MEMORANDUM

TO: Benito J. Garcia, Chief, HRMB
FROM: Steve Yanicak, NMED DOE Oversight Bureau, POC LANL
DATE: 7 September, 1995
SUBJECT: Response to RFI Report for Field Unit 1, SWMU 3-010(a), April 28, 1995

Figure 1 - Comparison of downhole soil-vapor and borehole soil results (total volatile concentration), SWMU 3-010(a), Borehole B2 (data from LANL RFI Report, SWMU 3-010(a), April 28, 1995)

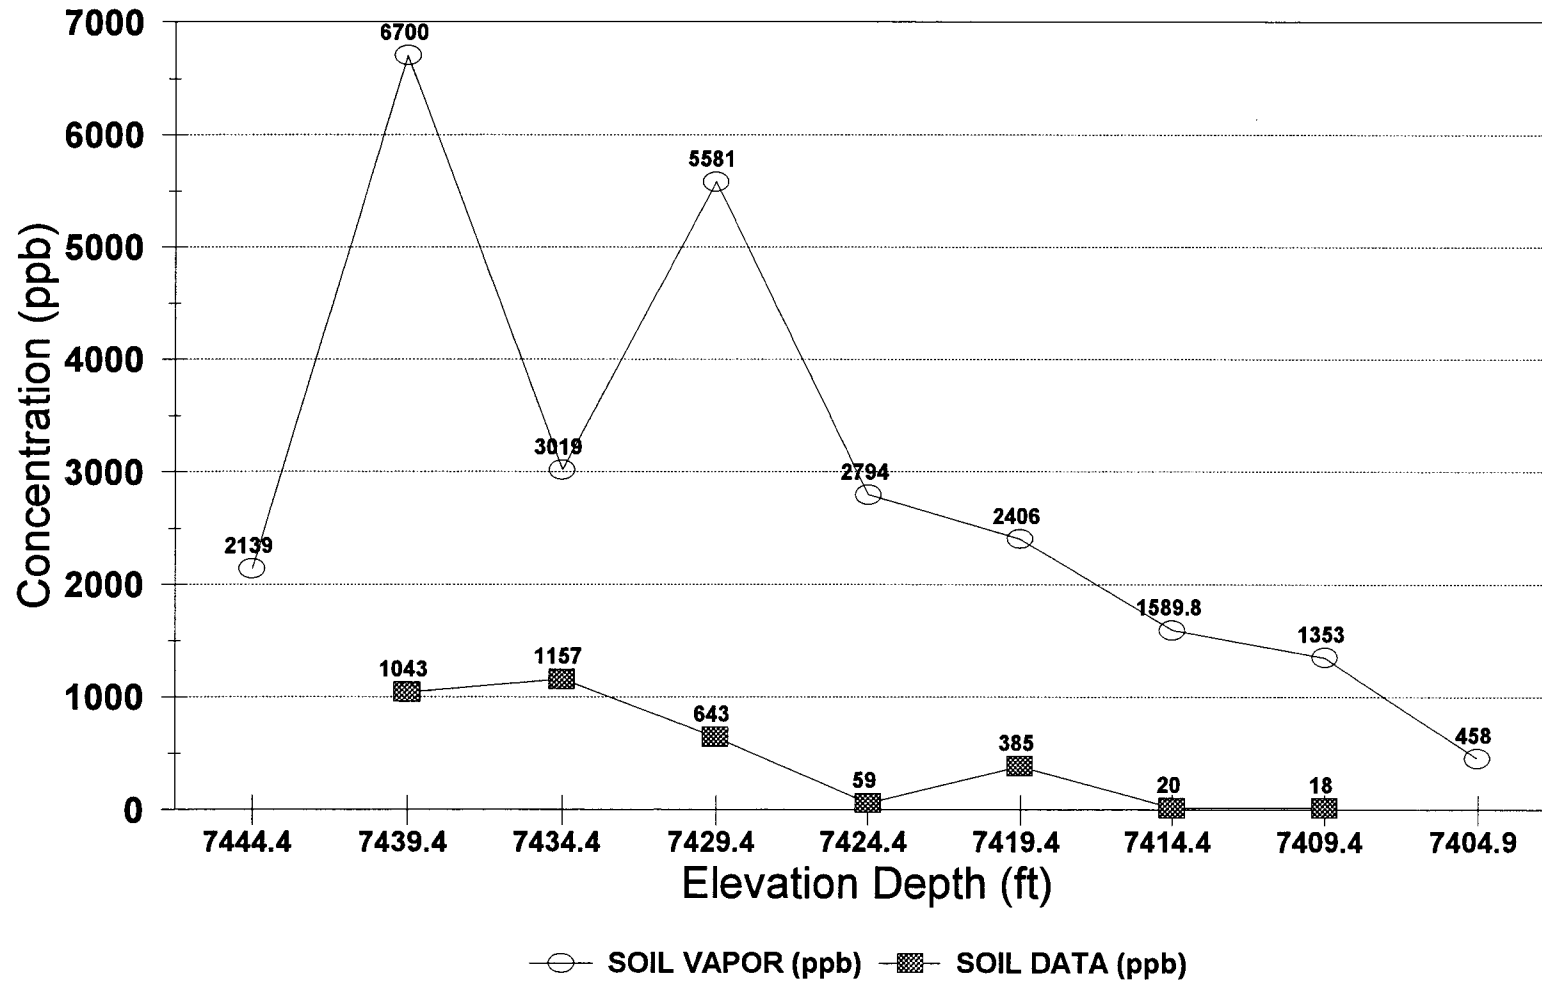
General Comment: Borehole soil data may not represent the actual concentration of VOCs in the subsurface due to the fact that downhole soil-vapor results (total VOCs) are considerably higher (see Figures 1 through 3) and show a larger suit of analytes than the borehole soil results. Note the large discrepancies in the 1,1 DCE results (Figure 4). An unknown portion of the VOCs may have been stripped (volatilized) from the soil/tuff during core retrieval, handling, sample preparation, etc. The elevated downhole soil-vapor results may be indicating that
